SUBJECT: REQUEST FOR ADDITIONAL INFORMATION REGARDING CENPD-137,  
SUPPLEMENT 2-P

## REQUEST FOR ADDITIONAL INFORMATION CENPD-137, Supplement 2-P

**Subject:** Supplementary Information to FTI's Response to NRC's Request for Additional Information on BAW-10168, Volume II, Revision 2, October 1992; RSG LOCA - BWNT Loss-of-Coolant Accident Evaluation Model for Recirculating Steam Generator Plants.

Fig-1

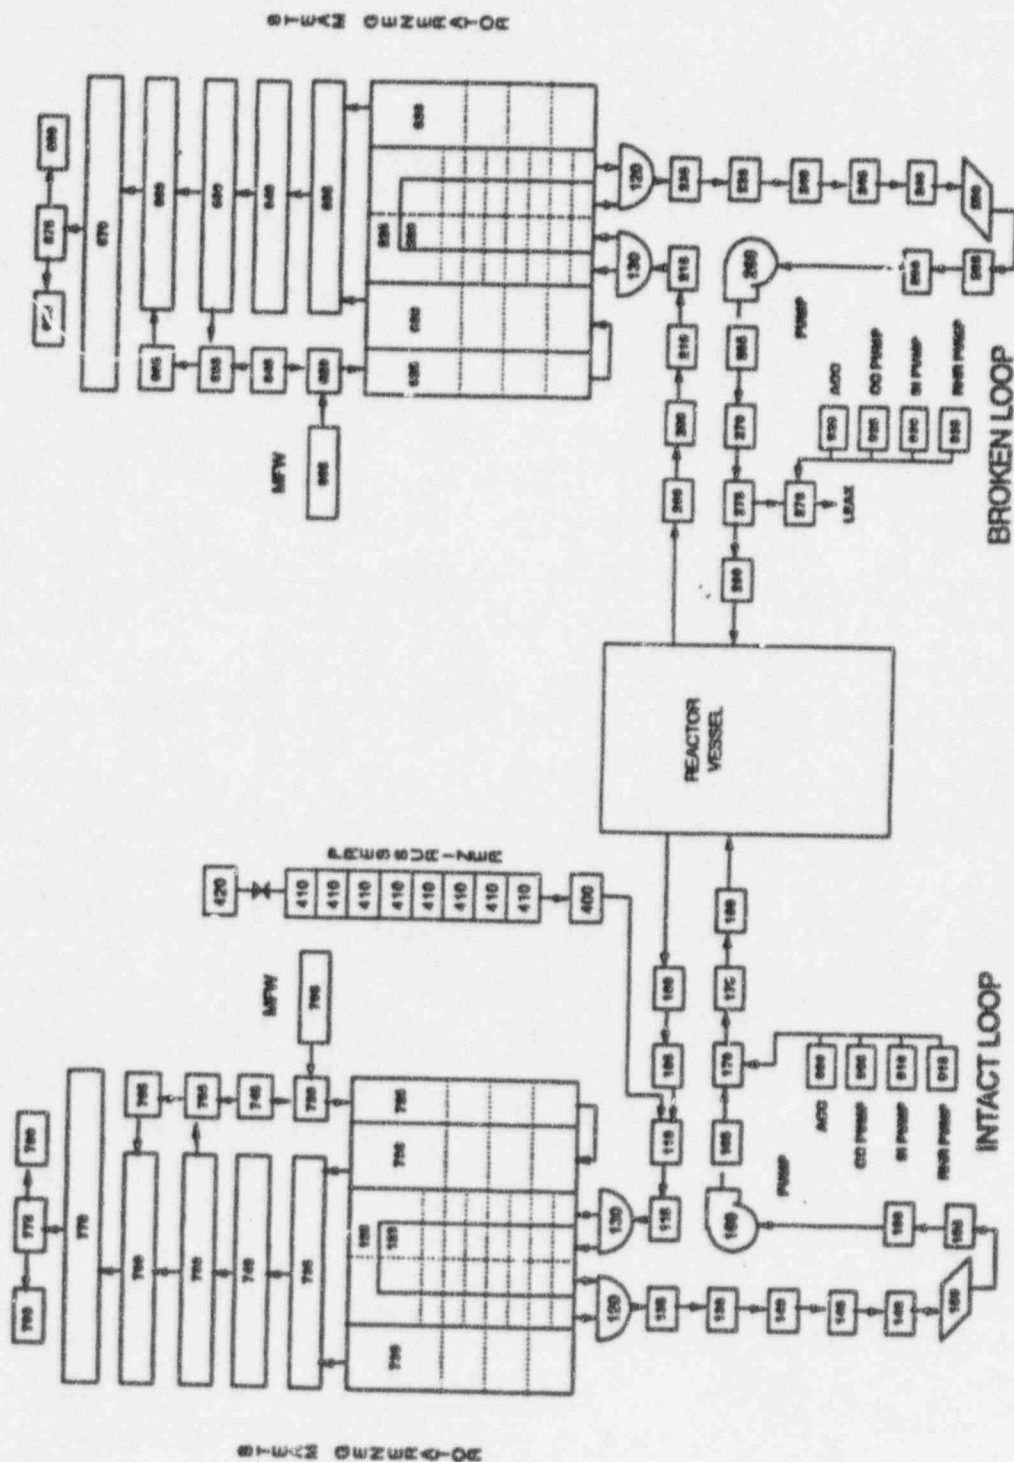
**Partial Loop Seal Clearing:** In response to questions regarding partial loop seal clearing, several additional SBLOCA cases were run using the plant model shown in Figure 1. Break sizes were varied from 1.6 to 2.0-inch to study the transition from no loop seal clearing to the clearing of the broken loop. It was found that RELAP5/MOD2-B&W predicts this transition for breaks between 1.9 and 2.0-inches. The liquid levels in the broken loop pump suction piping for these two cases are shown in Figures 2 and 3. Figure 4 shows the core liquid levels for the two cases. From Figure 4 it can be observed that the minimum core liquid levels of about 9.0-ft occur at about 1600 seconds and increase thereafter. For the 2.0-inch break, the core liquid level is about 10.0-ft at the time of loop seal clearing. The loop seal spillunder elevation corresponds to 3.0-ft height from the bottom of the core.

Fig. 3

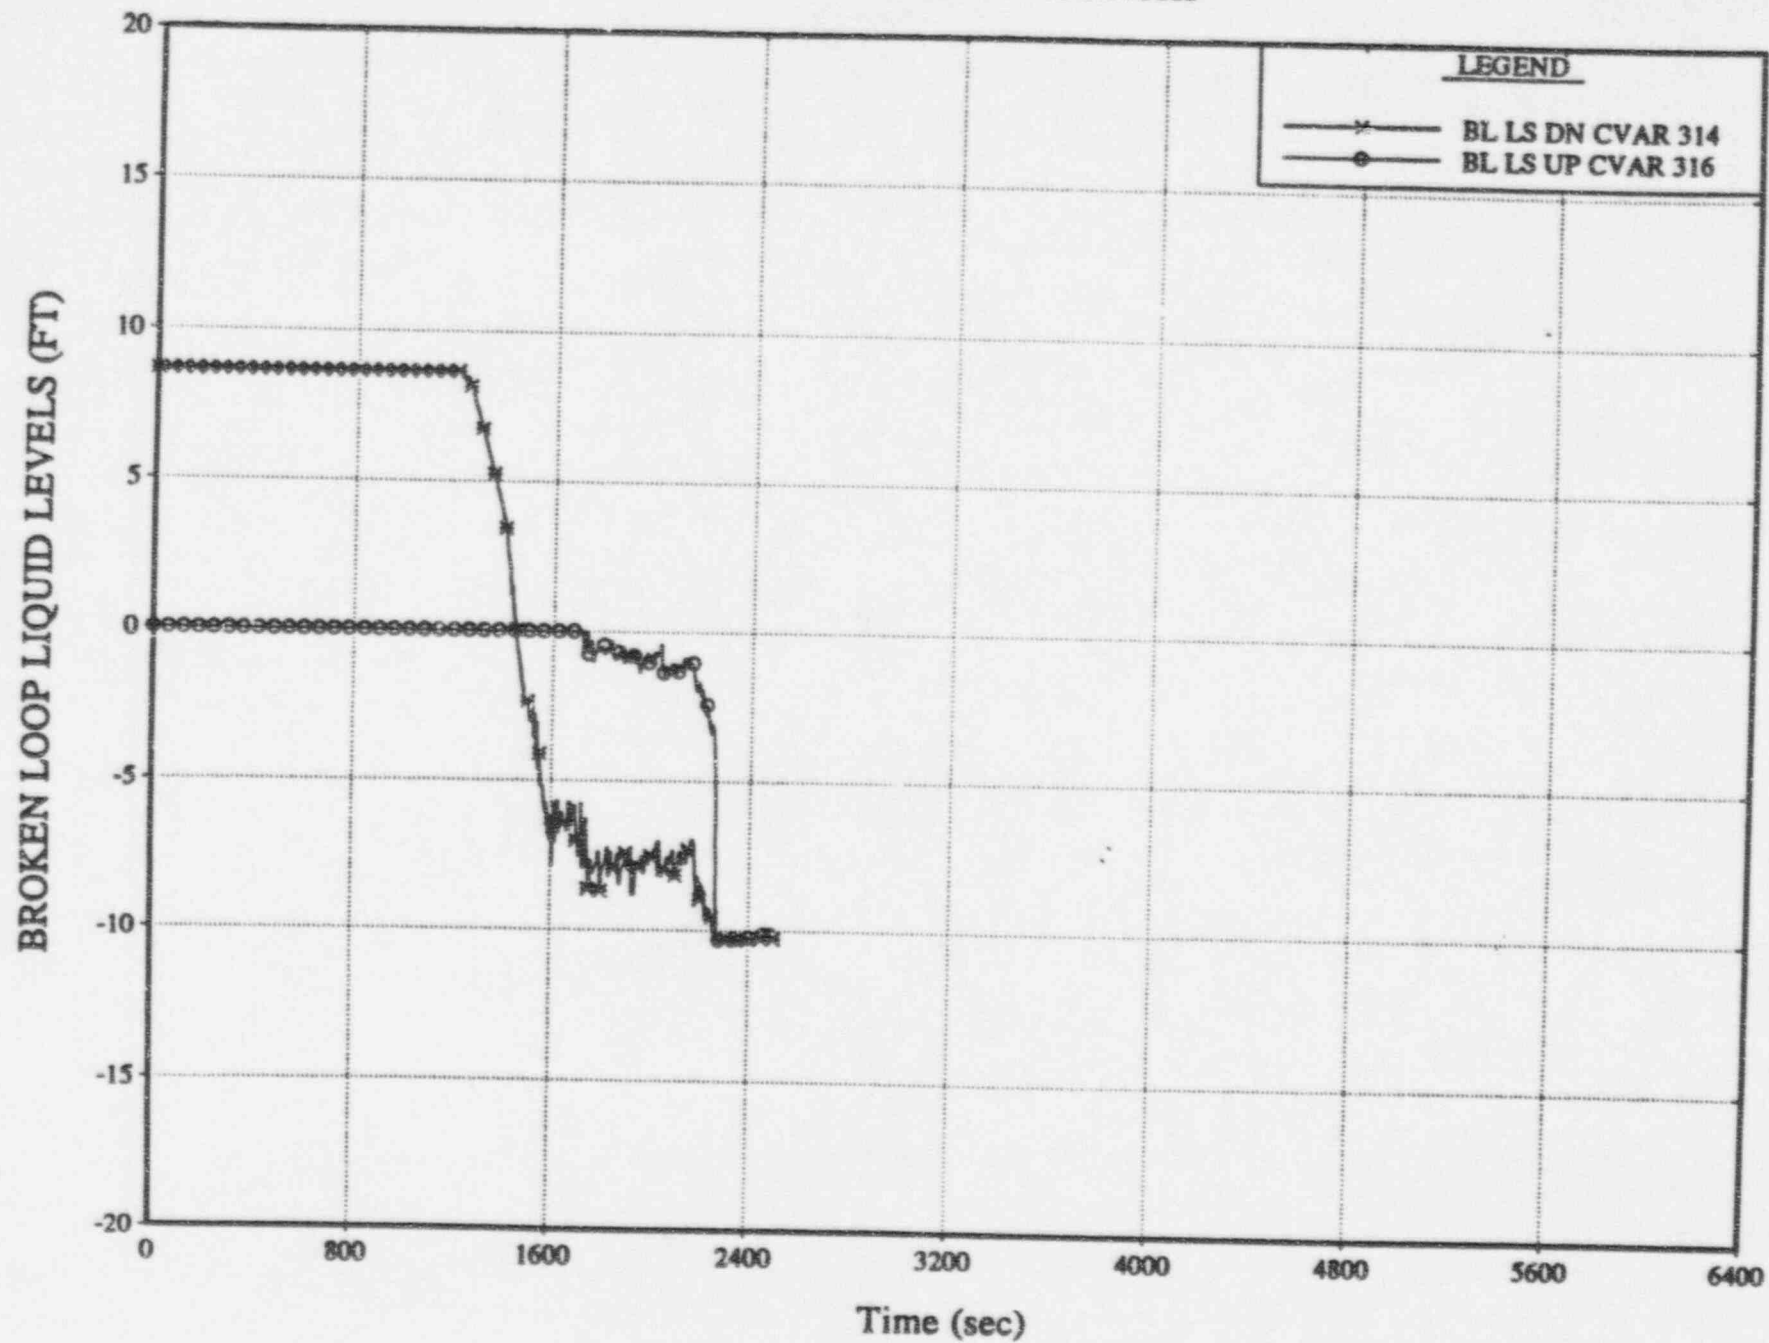
Figure 3 shows that the liquid level in the upside of the loop seal section starts to decrease after about 1700 seconds. The void fractions in Nodes 255, 260, and 265 are shown in Figures 6 through 8, respectively. From these figures it can be seen that the liquid level decrease in the loop seal upside section is caused by the increase in void fraction in the pump volume (Node 260). Steam venting from the loop seal occurs only after about 2200 seconds as shown in Figure 6. The pump discharge piping on the other hand is highly voided after about 750 seconds due to the steam flow from the upper head spray nozzles into the downcomer. At about 1600 seconds the break junction void fraction increases rapidly from zero to a highly voided state and the flow in the cold

Fig-5

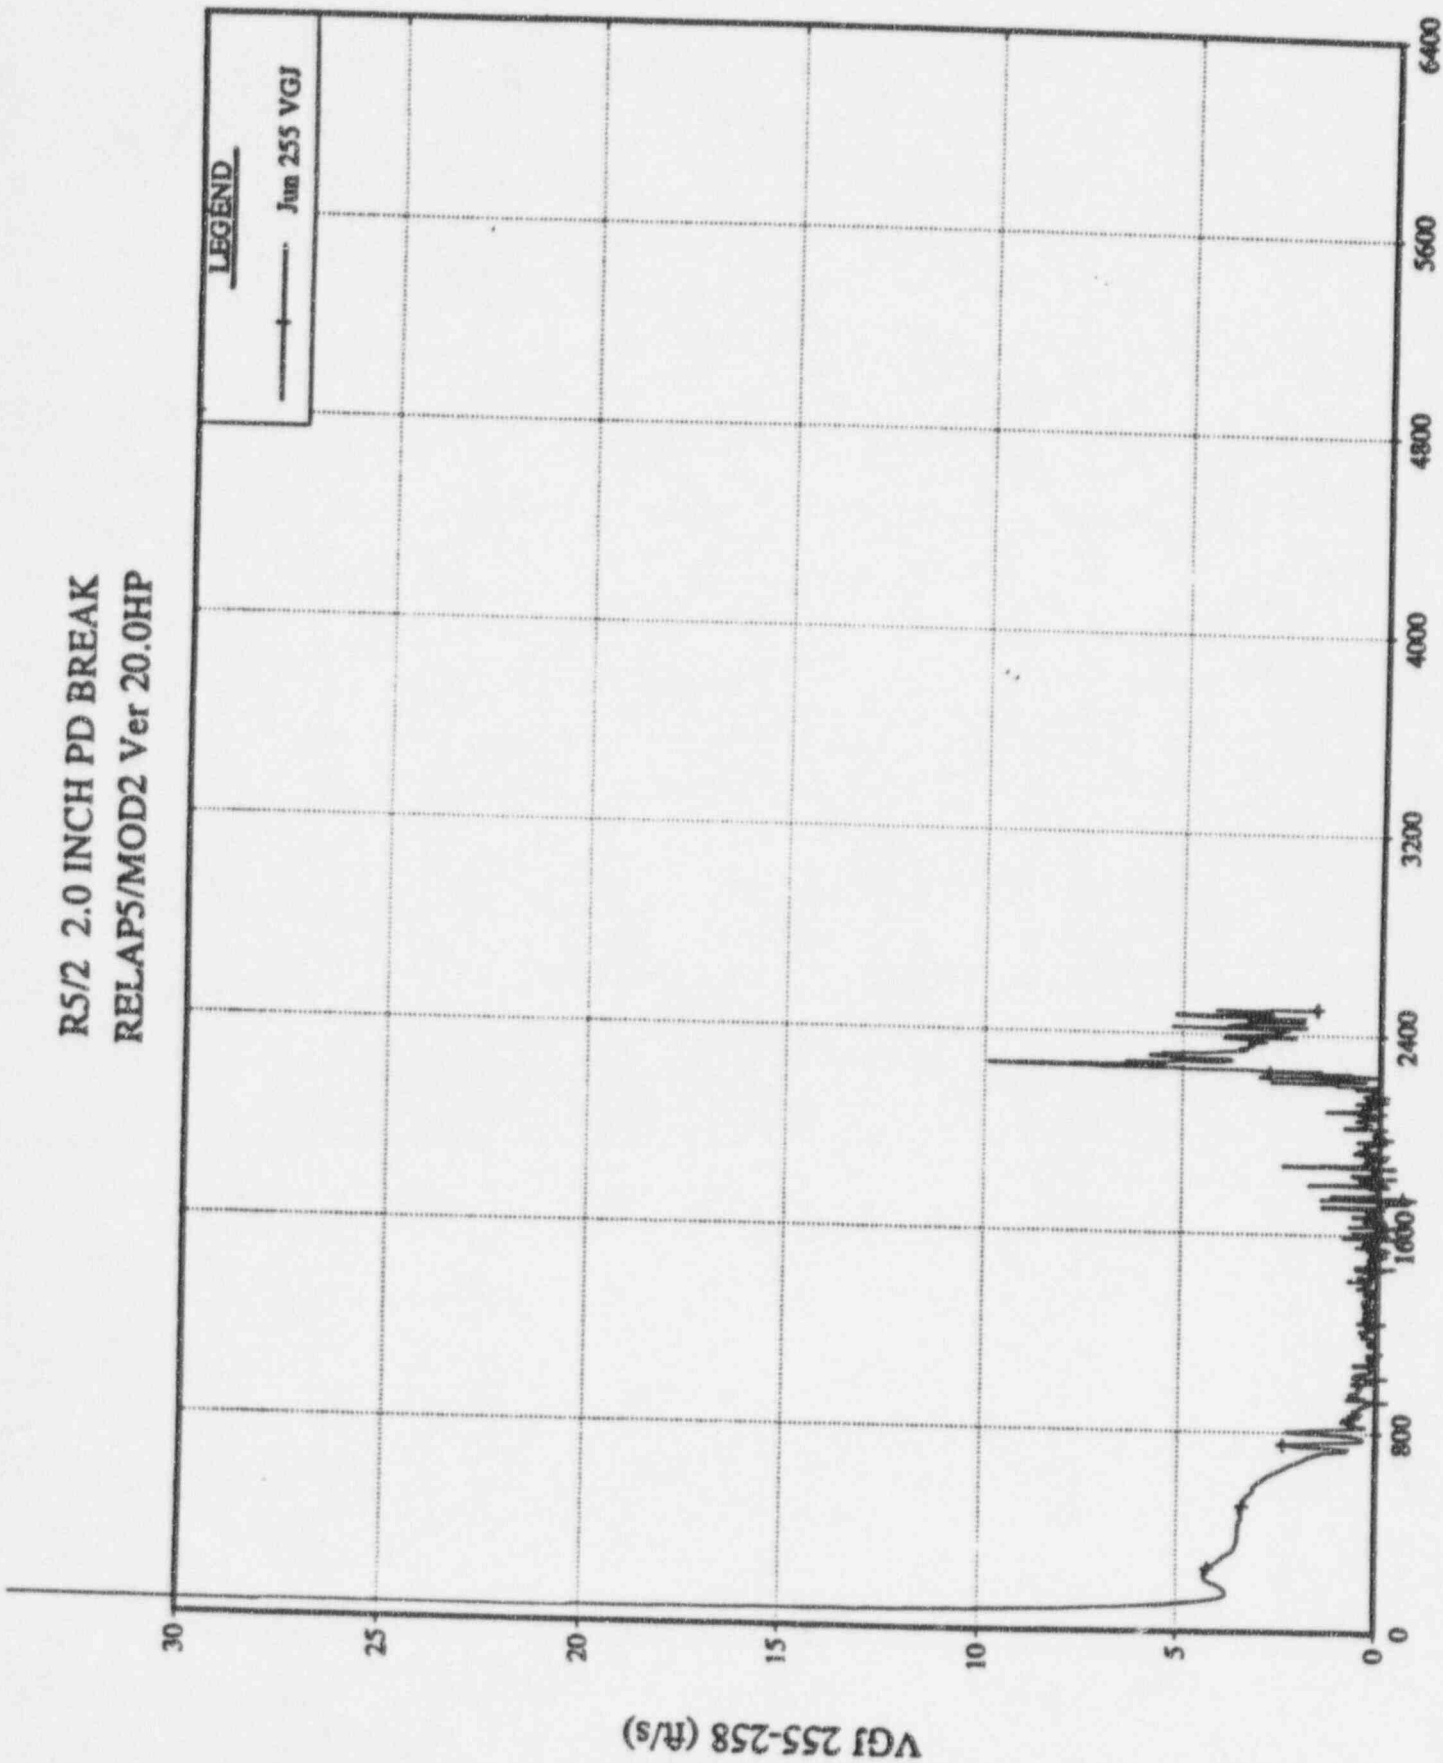
The steam velocity in the upside pump suction piping for the 2-inch break is shown in Figure 5. Once the steam venting process initiates, the head imbalance in the loop seal accelerates the steam flow and can be expected to reach a terminal velocity sufficient to clear the loop seal. For the 2-inch break the terminal steam velocity in the upside pump suction piping reaches about 10.0 ft/s at the time of loop seal clearing as shown in Figure 5. Tuomisto and Kajanto<sup>1</sup> show that the loop will clear completely for steam velocity greater than 6.2 ft/s (1.9 m/s) at 870 psia (60 bar). This is based on the flooding criterion for large diameter vertical pipes, Kutateladze Number  $Ku$  (See Equation 5 in Reference 1) equals 3.2. This flooding criterion is defined as a zero downward flow of falling film on the tube surfaces. They also show that, at pressures above about 145 psia (10 bar), vertical flooding is the limiting mechanism for loop seal clearing rather than the droplet entrainment from the stratified liquid in the horizontal section of the loop seal. For the 2.0-inch break case, the system pressure is about 1000 psia and therefore the loop will clear for steam velocities lower than 6.2 ft/s. The 1.9-inch break case in ROSA (see response to Question 14) demonstrates the loop seal clearing mechanism discussed above. For these break sizes, it is possible to accumulate some of the liquid in the loop seal once the initial acceleration of steam is complete as observed in the test. This liquid fall back is also observed in the RELAP5 simulation of the 1.95-inch break case which is discussed at the end of this section.
